## Appendix H. Outreach Report

# METROPOLITAN BRANCH TRAIL PINEY BRANCH ROAD TO BLAIR ROAD NW

COMMUNITY WORKSHOP #1  
MEETING SUMMARY

1A: 10-foot multi-use path on south side

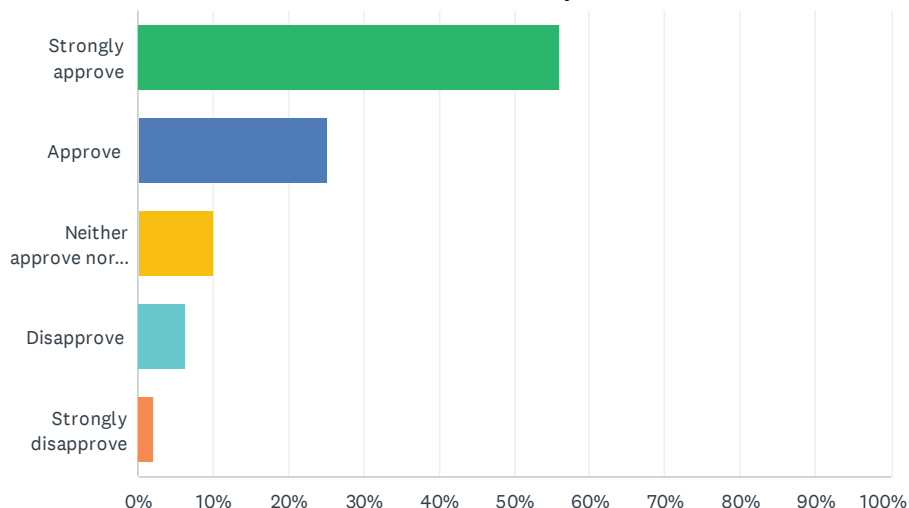
Q2 Based on the design for Alternative 1 and pros/cons, how supportive are you of Alternative 1?

1B: 4-foot two-way protected bike lanes on south side, 12-foot travel lanes

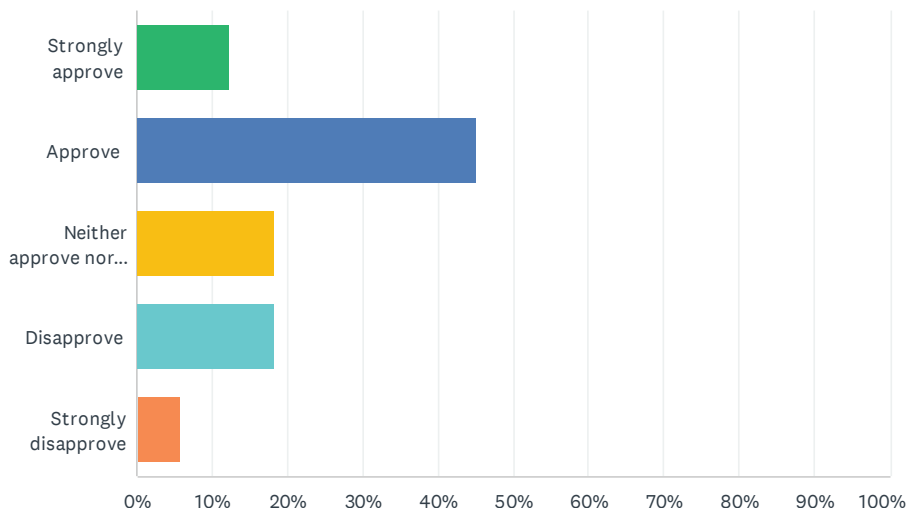
#	RESPONSES	DATE
1	Get it done ASAP to accommodate all users safely	1/8/2022 12:19 AM
2	I think this is a better option than A, but better *still* would be to remove some on street parking and make the PBLs *more* buffered/separated.	1/7/2022 3:50 PM
3	Alternative 2 does not provide enough space for a comfortable 2-way protected bike lane and creates a complicated intersection at the bottom of the ramp that requires sharp turns without adequate space.	1/7/2022 3:30 PM
4	I believe this is too narrow	1/7/2022 3:10 PM
5	It's not enough space for any significant volume of bikes and pedestrians.	1/6/2022 9:12 PM
6	Bike lane looks too narrow	1/6/2022 3:08 PM
7	a two-way facility AND a one way facility, with the southbound portion of the two-way disappearing is VERY confusing.	1/6/2022 2:43 PM
8	Make bike lanes wider even if it means fewer on street parking spaces.	1/6/2022 2:28 PM
9	A fully dedicated, bi-directional bike lane is a fantastic design decision, if more width were allocated to the bike facility. Considering the amount of green space between the sidewalk/trail and the cycletrack, more width can readily be provided.	1/5/2022 11:12 PM

10	At four feet, those two-way lanes seem way too narrow. Other segments of the trail have become incredibly popular, and a similar volume here would make that two-way portion very uncomfortable for some users.	1/5/2022 9:40 PM
11	I was caught in one of these types of lanes and I am not a fast cyclist. I went into the road to get around a slow family and was then caught in the street due to few openings in or out of the lane.	1/5/2022 9:29 PM
12	This is good but I think the first one is better.	1/5/2022 10:14 AM
13	Too narrow for bike lanes, confusing intersection.	1/4/2022 5:37 PM
14	Confusing bicycling patterns with non-continuous two-way protected lane and single continuous lane on North side of street. DDOT has issues with two way bike lanes that are inconsistent and cause more conflicts with traffic than necessary (for example, M street NE lanes)	12/29/2021 11:31 PM
15	Don't like counterflow bike lanes. Existing bike lanes (one on each side of road) are best for cycling and minimize chance you'll have to stop, dismount and walk your bike to cross a street.	12/15/2021 6:57 PM

16	Please get cars as far away from cyclists and pedestrians as possible to keep us safe! A narrow PBL would not work as well for bigger cargo bikes families use to transport their kids.	12/15/2021 4:18 PM
17	Would be better if you reduced street parking. But having bike and ped paths separate is a plus	12/14/2021 8:39 PM
18	Quit calling this sort of bike lane protected, if a car can physically enter it without being totaled and it's at the same grade, it's not a PBL, raise your damn standards and quit trying to come up with cheap solutions to a problem that's already been solved. Just literally copy and paste what they do in the Netherlands and quit half assing this stuff	12/14/2021 6:13 PM
19	Still pretty safe - I would hope that 'protected' is more than flex posts, but is a real barrier to keep people safe. Is there data on family usage on two-way bike lanes? I would prioritize whatever makes families taking kids to school safer. I also like that it's two-way on one side, but still keeps a parking-shielded protected bike lane on the other side.	12/14/2021 2:59 PM

2C. 10-foot multi-use switchback ramp, retaining wall and 7,300 SF green space

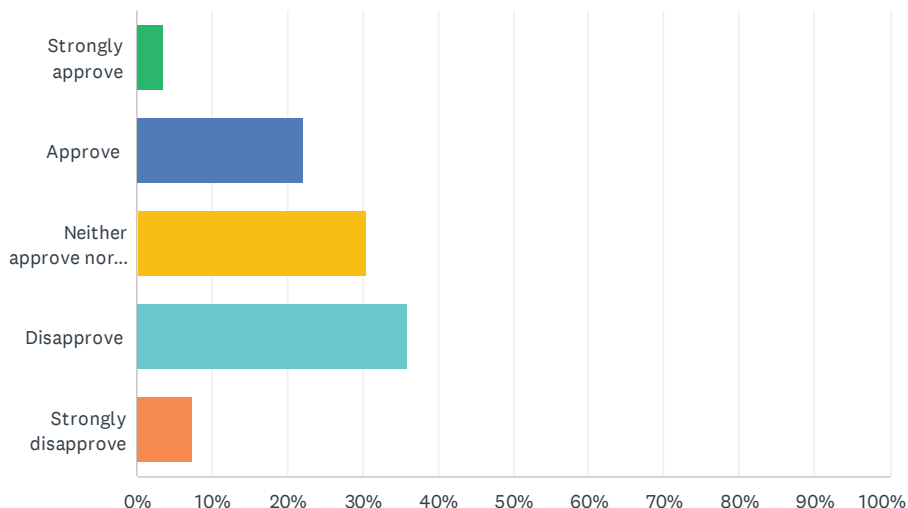
11	This looks very hard to navigate on a bike	12/15/2021 1:24 PM
12	I love that it keeps a lot of green space - the retaining wall is also an opportunity for public art OR could even put planters or ivy or something	12/14/2021 3:07 PM
13	Those turns seem very sharp. It's also inhospitable to pedestrians.	12/14/2021 1:52 PM
14	Tight turns and unattractive design.	12/9/2021 3:41 PM
15	No direct walkway will just mean green space will be trampled.	12/8/2021 1:59 PM
16	I like the green space. Is it easier to make the turn than in Alt. 2?	12/7/2021 11:54 PM

2G. 10-foot multi-use curvilinear path, staircase and 5,500 SF green space

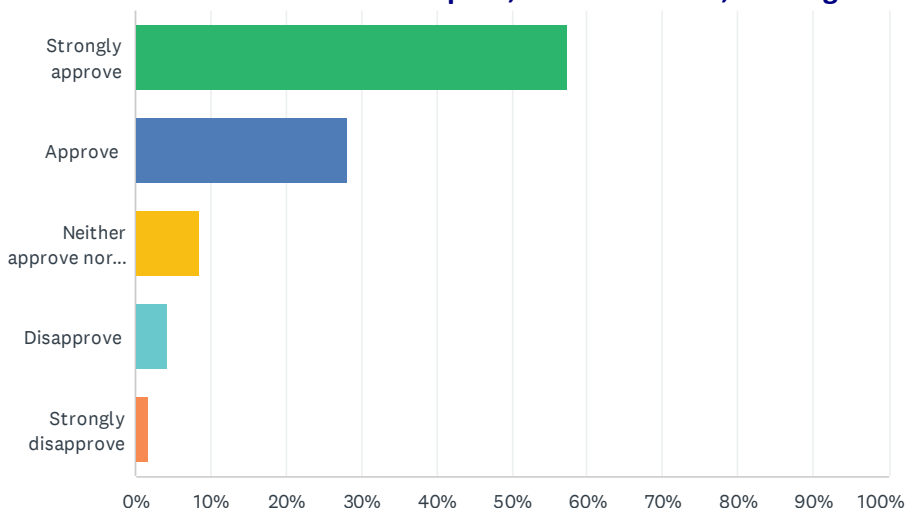
#	RESPONSES	DATE
1	Get it done ASAP to accommodate all users safely	1/8/2022 12:23 AM
2	Overall, better to have additional options for pedestrians, given the nature of the pathway. But all of these options are pretty good.	1/7/2022 3:53 PM
3	Stairs create potential conflict points between walking and rolling users if they use the ramp simultaneously, but stairs also offer a more convenient path for pedestrians.	1/7/2022 3:35 PM
4	This alternative provides the best fun for skateboarders	1/7/2022 12:57 PM
5	This looks to provide the best of both worlds, giving pedestrians a shortcut and cyclists a path easy to navigate. A+	1/6/2022 9:17 PM
6	As someone who frequently bikes around this area - and and also walks - this is the best design.	1/6/2022 8:50 PM
7	I don't imagine there will be much demand for this as a pedestrian route but if you don't put the stairs in then people will walk down the hill anyway.	1/6/2022 7:56 PM

8	Curves actually permit cycling, plus a direct walk route is highly preferable.	1/6/2022 1:59 PM
9	This is preferable to Alt 4 due to stairs, but both are good designs.	1/6/2022 11:21 AM
10	Alt 5 is similar to Alt 4, but explicitly addresses with the design what would ultimately become desire lines. This provides shortcuts for pedestrians to avoid the chicanes of the hill, while providing a usable grade for other users. Even though the green space will be "minimal" when compared to other designs, it is still plenty of available land.	1/5/2022 10:47 PM
11	Stairs seem like they could create additional conflict points between inattentive walkers and/or cyclists.	1/5/2022 9:51 PM
12	This is slightly better than Alt 4 but it still prioritizes an abstract bird's eye view that no one will ever actually see. The priority should be providing a convenient and direct route. The staircase here helps, but it is still not as direct as Alt 3, which is the best option.	1/5/2022 10:21 AM

4A.Neighborhood bikeway treatment with gateway

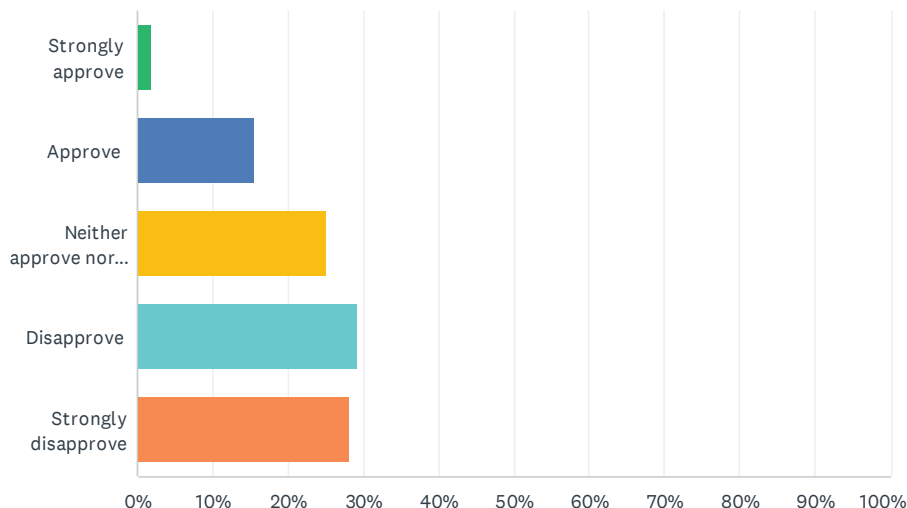
#	RESPONSES	DATE
1	This is an extremely narrow road already that is essentially alternating one-way at times. Narrowing it any further would make the road unusable. A business parks it vehicles along this street and moving trucks for the Gables need to get back here, as well as delivery trucks. There are also quite often other delivery cars/uber parked in the street itself just waiting even though they are blocking traffic. It is a very unsafe place for on rode bike traffic. Also it is already a tight space for emergency vehicles to get to. More space is needed back here, not plantings or artwork There has got to be a better alternative to using Spring Street	1/7/2022 11:36 PM
2	I am new to biking, in part due to Covid and the way it's changed our lives (more time at home, less metro access, etc.). I am very nervous about riding near cars and I live in Takoma, so I strongly prefer a map with more orange and green (off-street trails and protected bike lanes) and less red (on-street biking). I appreciate the art space but I prioritize my safety first.	1/7/2022 6:12 PM

12	The existing green-painted facility will be confusing for many users, as it is designed as though it were a dedicated bike facility, while actually being a pedestrian-only facility. Existing vehicle speeds may be low, but the frequency of illegal parking is high.	1/5/2022 10:52 PM
13	It'd be great if there was an alternative that created more of a visible trail. Sharrows rarely seem to encourage drivers to slow down or drive cautiously around people. It may not be family or beginner friendly. Are there contingencies if vehicle volumes or speeds change? Between the two alternatives, the lack of chokers to slow vehicles mid-block makes this a less desirable alternative.	1/5/2022 10:13 PM
14	This option is okay, but Alt 2 is much better because it includes traffic calming.	1/5/2022 10:23 AM
15	Speed reducing mechanisms for vehicles would be good.	12/16/2021 6:02 PM
16	I guess art is good. I prefer this to the Chokers which I do not like. Woonerf or different paving to indicate shared space would be better than plain street.	12/15/2021 7:18 PM

4B.Woonerf with chokers

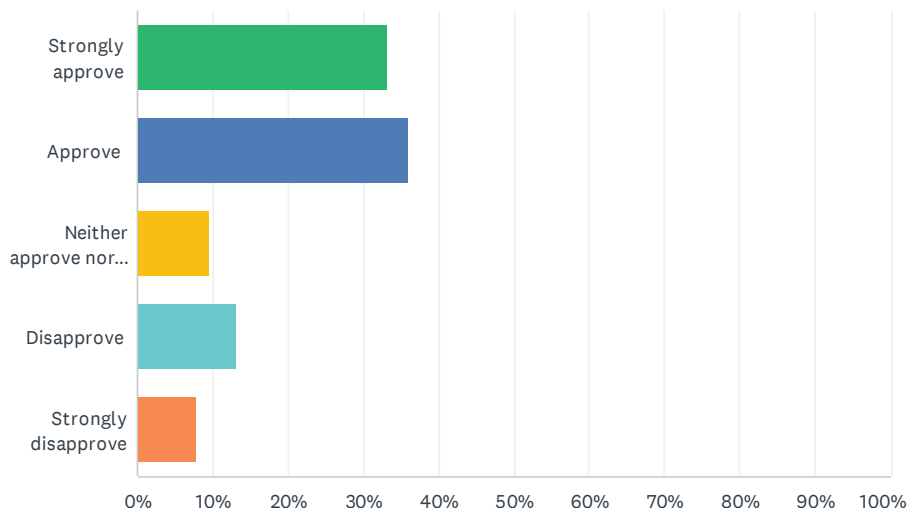
#	RESPONSES	DATE
1	This is an extremely narrow road already that is essentially alternating one-way at times. Narrowing it any further would make the road unusable. A business parks it vehicles along this street and moving trucks for the Gables need to get back here, as well as delivery trucks. There are also quite often other delivery cars/uber parked in the street itself just waiting even though they are blocking traffic. It is a very unsafe place for on rode bike traffic. Also it is already a tight space for emergency vehicles to get to. More space is needed back here, not plantings or artwork There has got to be a better alternative to using Spring Street	1/7/2022 11:36 PM
2	As an active cyclist I can tell you that chicanes and chokers put cars and cyclists in contention with each other (cyclist always loses, always having to look backwards to see what the car is going to do while looking forwards to navigate the chicane/choker), and also can be dangerous for cyclists at night, in the rain, ice, and snow even when no cars are around.	1/7/2022 6:41 PM

7	Like chokers for slowing vehicle speeds. Also support reducing public car storage on important connecting streets	1/7/2022 3:14 PM
8	DANGEROUS	1/7/2022 2:40 PM
9	I support this. Please maximize the use of curb narrowing the calm vehicle traffic. I support whatever on-street parking removal is necessary to make the safest road.	1/7/2022 1:05 PM
10	add additional MBT wayfinding throughout clearly communicate that people walking and biking have priority here.	1/7/2022 9:47 AM
11	This is much closer to what a calmed street looks like.	1/6/2022 10:52 PM
12	As a resident of Takoma Park, MD, which has used chicanes to narrow the city streets, I've noticed that they are effective. Driver behavior on this streets is much more tolerable than comparable streets without them. Let's do this!	1/6/2022 9:24 PM
13	Chokers are the better option here	1/6/2022 8:55 PM
14	There is only one way in or out for all the residents of Spring street and this area gets a lot of emergency calls, so there is a lot of emergency vehicle usage. Choking off the street will lead to nightmare scenarios. I don't live there, but I know it will be bad. I live near enough to see the chaos that already prevails.	1/6/2022 7:51 PM

28	Can we get a raised crosswalk at the intersection with Chestnut St?	12/14/2021 3:07 PM
29	not a trail but the choker will at least send a visual message to users that this is special. could this be a woonerf?	12/14/2021 2:27 PM
30	This is better than alternative 1 but it still feels like we can do more to prioritize and protect trail users. There is a lot of parking back here....really feels like we're doing a lot of work to avoid considering the best option, which is keeping the trail on Blair.	12/14/2021 2:00 PM
31	Better than Alt1, but still doesn't provide safe cyclist/runner protection. DDOT should create an Alt3 option to add a protected path the way the MBT is in almost all other places.	12/13/2021 11:14 AM
32	This should be a protected bike lane.	12/13/2021 9:04 AM
33	There's tons of parking in the nearby garages and people pay to live near a metro station so they can avoid owning a car. I would get rid of as much parking as possible to create a pedestrian-friendly place and would save what's left for disabled parking and short-term rideshare/delivery	12/11/2021 1:29 PM

5A. 10-foot multi-use path with 5-foot retaining wall (8.3% slope, max.)

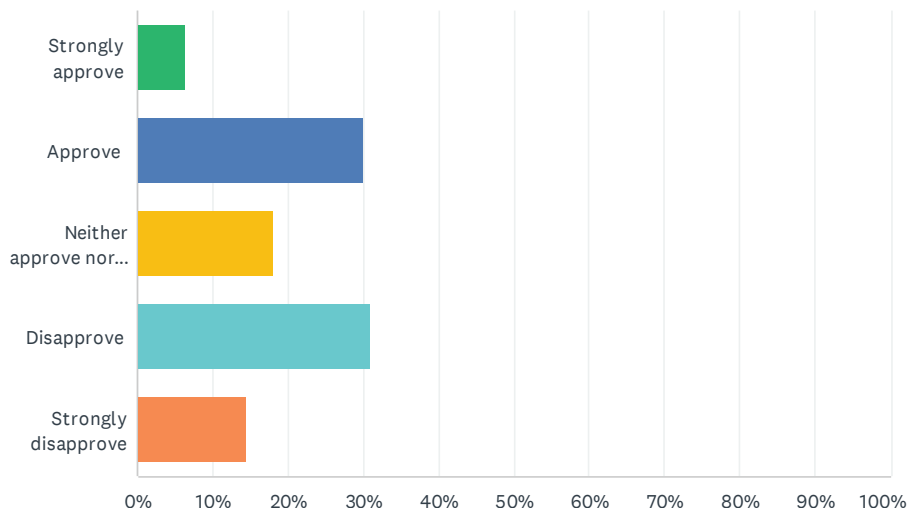
10	Too steep	1/6/2022 3:10 PM
11	Too steep	1/6/2022 2:44 PM
12	10' adjacent to a retaining wall is more like 8' of useable width (people cant walk or cycle inches away from a wall), which is way below standards.	1/6/2022 2:05 PM
13	If we have to accept a steeper grade due to costs, it should at least be a wider trail to provide more separation between faster and slower users.	1/6/2022 11:11 AM
14	A 10' design width will soon become a chokepoint in the network, as the retaining wall and existing construction are unable to be widened in the future, unlike the grade trails elsewhere.	1/5/2022 10:57 PM
15	Make the trailer wider, if possible. Use one of the 12-ft alternatives.	1/5/2022 10:18 PM
16	I don't understand why you'd pursue an inferior 10-ft wide option if a 12-ft one is possible. This trail may be crowded, so making it wider is important. Also, the aesthetics of retaining walls are not nearly as important as providing a safe and efficient trail.	1/5/2022 10:27 AM

5C. 12-foot multi-use path with 6-foot retaining wall along CSX embankment and 3-foot retaining wall along 343 Cedar Street property (5% slope, max.)

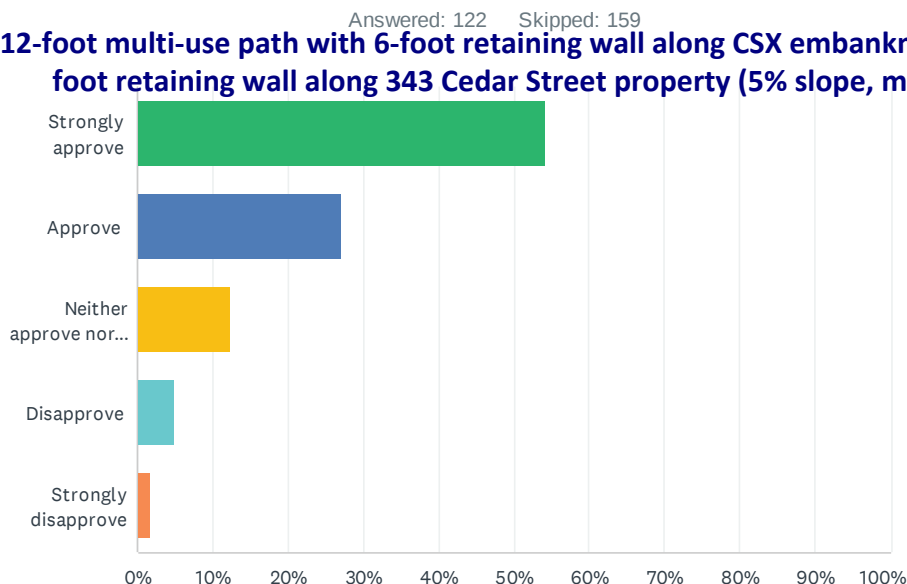
Most importantly, the gentler 5% grade will be much easier to climb than the 8% grade proposed for alternatives 1 and 2.

21	A 12' trail is preferable here because it will be a popular pedestrian path to the Metro and shops for residents.	1/4/2022 3:56 PM
22	Seems the most favorable option and would allow for increased privacy for the condos along that path	12/30/2021 4:09 PM
23	Don't like double walls, riding next to walls is not pleasant and reminds me of the time I got knocked into a wall by an idiot on a scooter. Collision with wall is seriously no fun, concrete is very hard.	12/15/2021 7:24 PM
24	gentler slope seems better. can the retaining walls have mural space?	12/15/2021 12:45 PM
25	Eh, maybe worth saving the money	12/14/2021 2:47 PM
26	Maximize width and grade improvements. Seems far superior to other options.	12/14/2021 2:03 PM
27	I prefer the wider path and gentler slope.	12/13/2021 9:06 AM
28	Trail grade is less steep as compared to the presented alternatives.	12/9/2021 3:21 PM
29	What is sloped 5%? The greenspace?	12/8/2021 12:51 AM

6C.1 20-ft multi-use path, two-way crossing on the west side

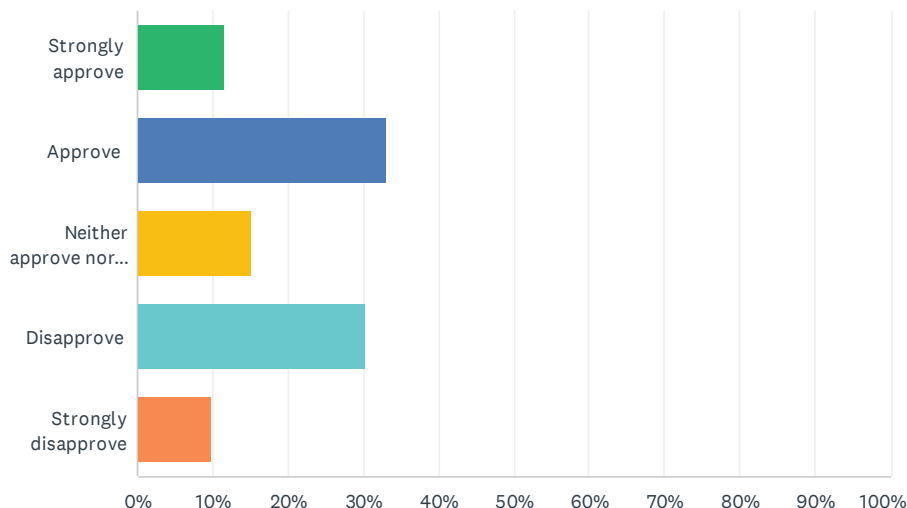
12	extremely confusing/tight turns compared to the alternative	1/6/2022 2:44 PM
13	This is okay but inferior to Alternative 1.	1/6/2022 11:04 AM
14	Keeping the trail access closest to the crossing will reduce confusion, keeping cyclists from attempting to ride up Blair instead of taking the trail. The stop line, signage, and lights must be positioned to correctly identify where to stop, so as to avoid drivers from stopping on top of the trail.	1/5/2022 11:01 PM
15	The twisting bike lane to cross Cedar St. will create confusion and has a lot of potential conflict points.	1/5/2022 10:26 PM
16	Bikes will be too close to cars in this alternative. Also, the path is not intuitive.	1/5/2022 10:29 AM
17	Clear signage would be helpful	12/22/2021 10:46 AM

18	This is way too kooky. It's not straight, gotta cross two crosswalks, plus I'm going to have to look a full 180 over my shoulder to check for cars when riding northbound, versus the straight one where it's just a 45 degree glance to the left.	12/15/2021 7:30 PM
19	That bike path looks confusing. (I'm not a cyclist, though, I'm mostly a pedestrian.)	12/15/2021 12:43 PM
20	Cyclists need maximum separation from cars	12/14/2021 8:36 PM
21	I worry about drivers accelerating after they turn right from Blair onto Cedar right as they cross the bike lanes. I do prefer the shorter turning radius on that corner in this alternative compared to alternative 1	12/14/2021 3:30 PM
22	This looks good, so long as it is physical barriers, not flexposts	12/14/2021 3:15 PM
23	Like the protected bike path at the junction better. Using the green paint in the junction will help cyclists find it	12/14/2021 2:51 PM
24	seems more legible for people on foot or bike	12/14/2021 2:31 PM

**6A.2 5-ft two-way protected bike lanes on the east side**

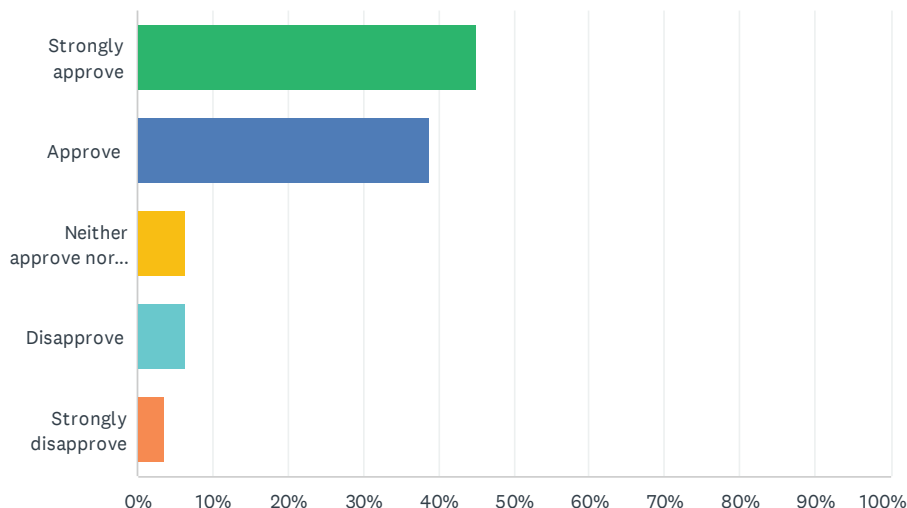
5	There should be a continuous 2-way protected bike lane (PBL) along the east curb of 4th St. NW from Whittier to Cedar St (as proposed from Aspen to Cedar and by converting 4th one-way southbound plus repurposing east side vehicle parking between Aspen to Whittier), and a new traffic signal at Whittier St and Blair Rd to facilitate a safe trail crossing.	1/7/2022 3:35 PM
6	Don't understand the reference on transitioning from two way to one way south of Aspen Street. Need more information and a better map to show Aspen Street.	1/6/2022 10:55 PM
7	I agree with WABA: None of the proposed on-street facility types for Whittier or 4th St are sufficient to create a continuous and safe trail experience that is suitable for all ages and abilities. Instead, we propose a new multi-use trail on the south side of Whittier St (using park land and DDOT right of way) and a continuous 2-way protected bike lane along the east curb of 4th St. from Whittier to Cedar St (converting 4th one-way southbound and repurposing existing parking)	1/6/2022 9:55 PM

6C.3 6-ft one-way bike lanes on east and west sides

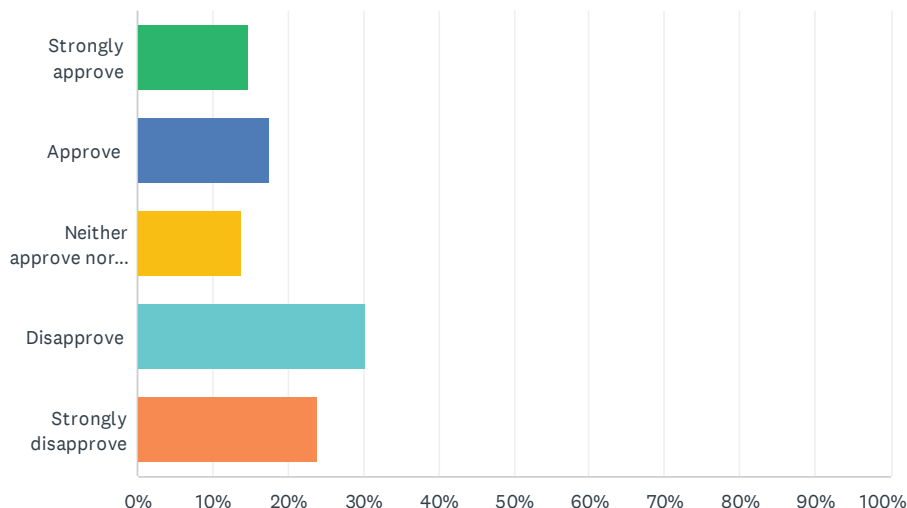
8	Door zone, painted, unprotected bike lanes should be cut from planning at this point.	1/6/2022 10:57 PM
9	Should be a new multi-use trail on the south side of Whittier St (using park land and DDOT right of way) and a continuous 2-way protected bike lane along the east curb of 4th St. from Whittier to Cedar St (converting 4th one-way southbound and repurposing existing parking)	1/6/2022 7:39 PM
10	I prefer protected bike lanes over the alternatives	1/6/2022 7:16 PM
11	why isn't the west side bike lane between the curb and the parking lane? in this alternative cars parallel parking will be crossing the bike lane to park - this will also lead to lots of cars simply double parking in the bike lane	1/6/2022 6:09 PM
12	Not protected bike lane	1/6/2022 3:16 PM
13	These bike lanes would be parking and blocked all the time. Not worth building.	1/6/2022 2:13 PM
14	Why do the cons listed exclude the fact that this is a painted, not protected, bike lane? That is a serious disadvantage that makes our streets less safe.	1/6/2022 11:01 AM

21	Cars will park or double park in bike lanes on both sides of the street. High danger of dooring on west side bike lane.	12/30/2021 11:48 AM
22	Transition between one way and two way bike facilities is not intuitive	12/29/2021 11:52 PM
23	This is best, you can ride on your side of the road and easily change to the traffic lanes when there are obstructions liked stopped or parking cars. I like that it connects directly and doesn't require weird road crossings or counterflow riding like a change to a 2-way bike lane would. Just let me ride in a straight line!	12/15/2021 7:40 PM
24	Please no more unprotected door zone double parking lanes.	12/14/2021 3:47 PM
25	Unprotected bike lane with parking on the right means I won't feel safe riding in it and families definitely don't. Ripe for getting hit by a car on the left and doored on the right. Crosswalks should be raised	12/14/2021 3:19 PM
26	Inconsistent with the rest of the MBT	12/14/2021 2:54 PM
